# MAAA APPARELS Ltd.

Plot # 1187, 1214-15, Gacha Maddhapara, Gazipur Sadar  
(23.936233, 90.376661)

30<sup>th</sup> August 2016

# Observations

# High Stress Column

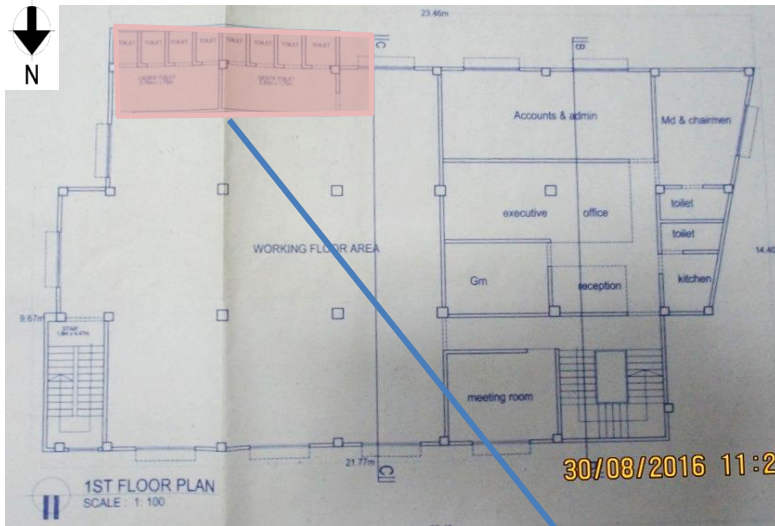
Cursory calculations indicate that the working stresses to the Ground Floor and First floor columns are at a high level. Building Engineer to review design, loads and columns stresses.

Column sizes in provided schedule are bigger than on-site condition.

Toilet partition wall and build-up observed at south-east cantilever .

The date of construction of the 4-storied building is 2006-2007. The reinforcement quantities recorded at Ground Floor level using the Ferro scanner coincided with the values provided in the Column Schedule. Brick aggregate was observed on-site. No loading plan was provided for the building.

Item No.	Observation	Recommended Action Plan	Recommended Timeline
1	High Stress Column	Limit Live Load to 2.0kN/m <sup>2</sup> on all floors immediately.	<b>Immediate - Now</b>
2	High Stress Column	Verify in-situ concrete strength and aggregate type by taken min. 4 nos. 100mm dia. core samples from columns.	<b>6-weeks</b>
3	High Stress Column	The Detailed Engineering Assessment to be completed.	<b>6-weeks</b>
4	High Stress Column	Produce and actively manage a loading plan for all floor plates within the factory, giving consideration to floor capacity and column capacity.	<b>6-weeks</b>
5	High Stress Column	Complete implementation of any remedial works deemed necessary by the DEA.	<b>6-months</b>
6	High Stress Column	Continue to implement loading plan.	<b>6-months</b>
7	Discrepancies between Structural drawings and site observations	Building Engineer to survey as-built structure and prepare accurate as-built survey information, including all columns, beams and slabs as part of DEA.	<b>6-weeks</b>

Column layout plan

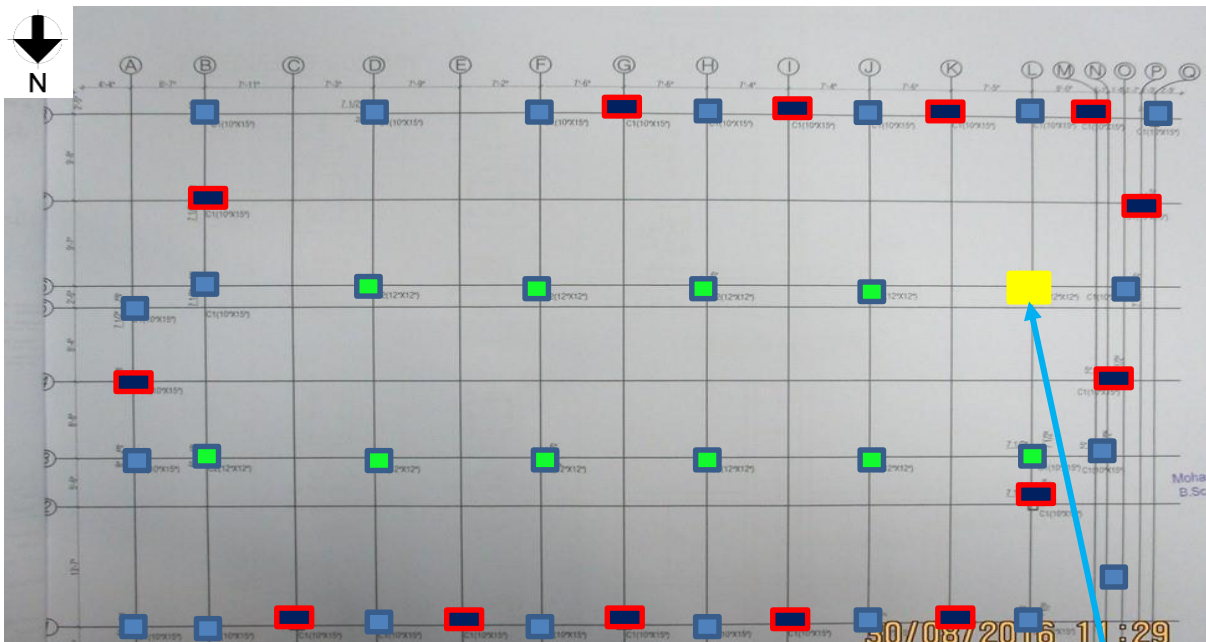
This column is not shown in column schedule. On site measurement the column size was 10x10 inch and 4 nos. of rebar observed by Ferro scanner.

External columns are measured 10x10 inch but in column schedule it is shown as 10x15 inch. Some brick columns are found which is marked as red colour on column layout plan.

**No structural drawings of roof shed, steel deck and steel stair were found**

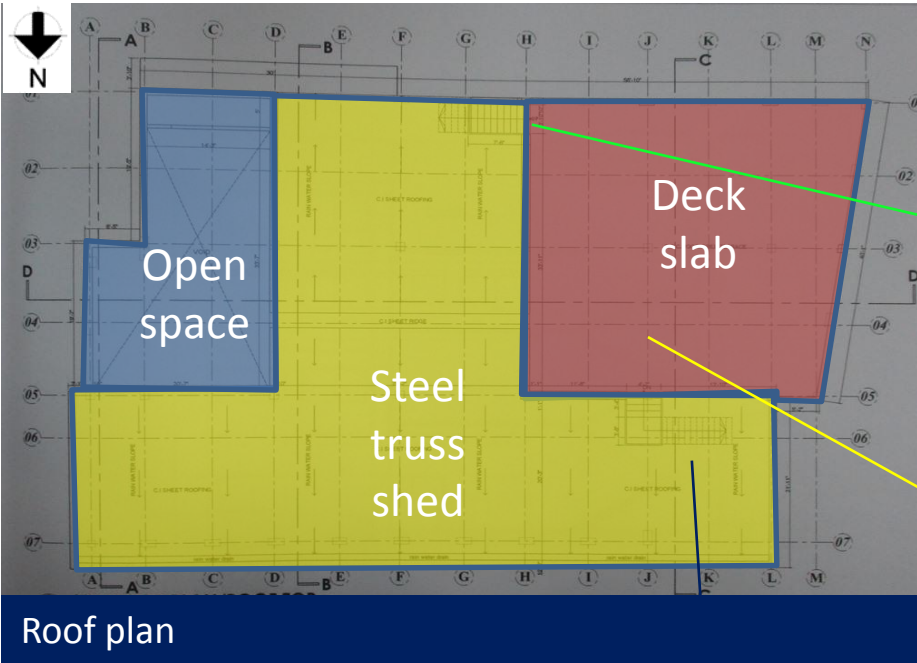
Steel stair at south poorly connected with I beam of deck slab

Steel stair poorly connected with partition wall and floor.

Connection with column is not clear. No details drawings was found for connection.

8	No structural drawings of roof shed, steel deck and steel stair were found	Building Engineer to survey as-built structure and prepare accurate as-built drawings as part of DEA.	<b>6-weeks</b>

Column Layout Plan

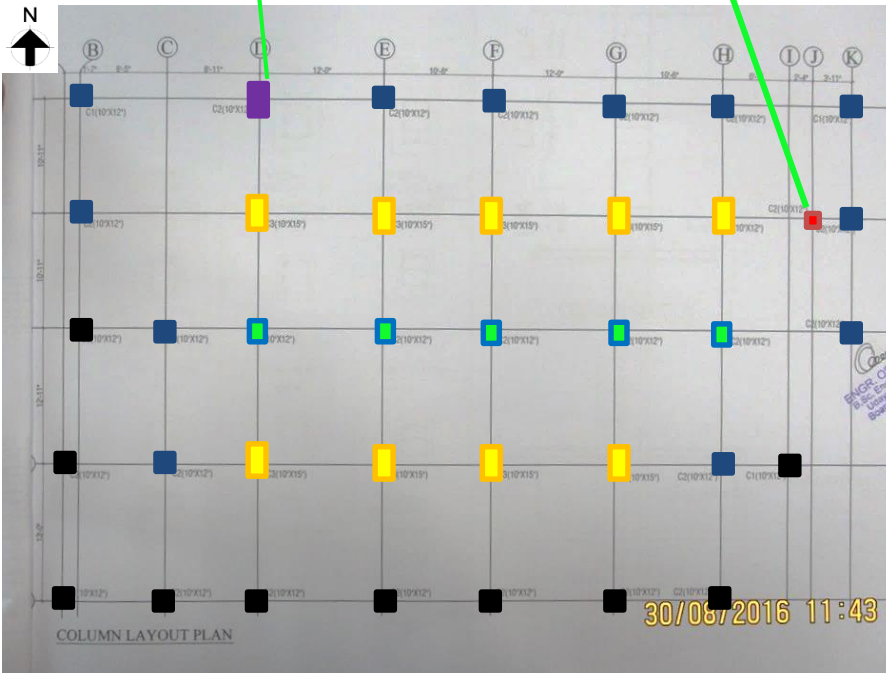
Column sizes are not matched with column schedule. One external column was found 10x15 inch shown in purple. On site measurement black marked columns were found 10x10 inch which is not shown in column schedule.

One brick column was found at GF & 1<sup>st</sup> floor marked as red in column layout plan which does exist at upper floor.

14	Discrepancies between Structural drawings and site observations	Produce and actively manage a loading plan for all floor plates within the factory, giving consideration to floor capacity and column capacity.	6-weeks
15	Discrepancies between Structural drawings and site observations	Continue to implement loading plan.	6-months
16	Discrepancies between Structural drawings and site observations	Complete implementation of any remedial works deemed necessary from out come of engineering assessment.	6-months
